VEHICLE RECALL

SC290

Subject: Step Support Pedestal Weld Quality — CV Model Chassis

Figure 2 — Step Pedestal Welds

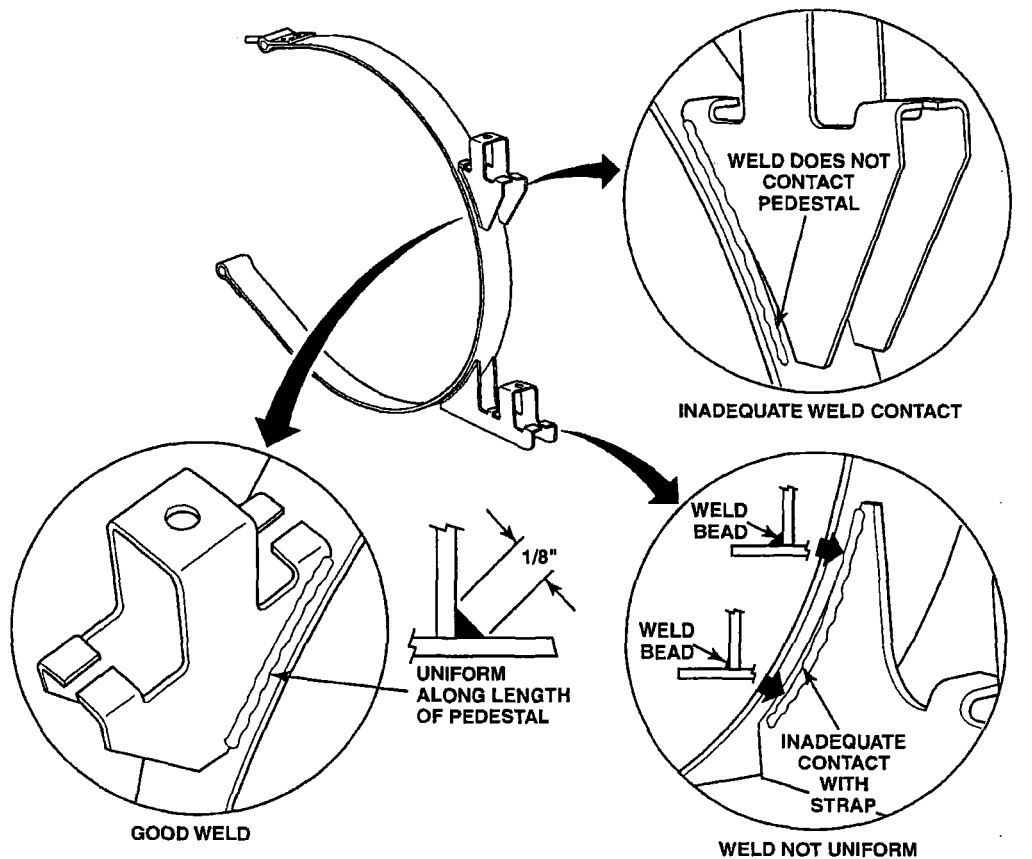
The bead of weld attaching the pedestal to the strap must have equal coverage on both the strap and pedestal. Check both step pedestals (two pedestals per strap). The weld bead should be approximately 1/8" (3.1 mm) wide with equal contact between the pedestal and strap along the entire length of the pedestal. If the weld is less than 1/8" (3.1 mm), or the weld does not contact both the strap and pedestal, the strap must be replaced with new straps (part Nos. 8MB429 for painted finish, or 8MB430 for stainless steel polished finish). Refer to the following figure for illustrations of adequate and inadequate welds.

Figure 3 — Wooden Block Cut to Contour of Fuel Tank

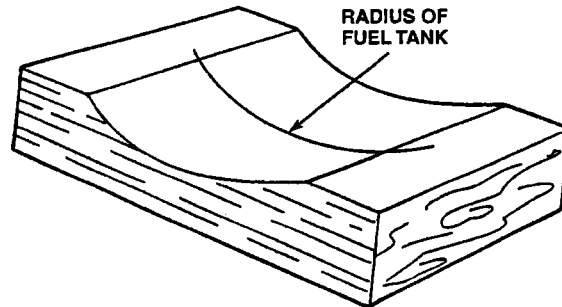
Remove and replace one strap at a time. When removing the strap, it will be necessary to support the fuel tank with a floor jack and wooden block. Cutting a wooden block to the contour of the fuel tank as shown in the following illustration will minimize the risk of the fuel tank falling from the jack.
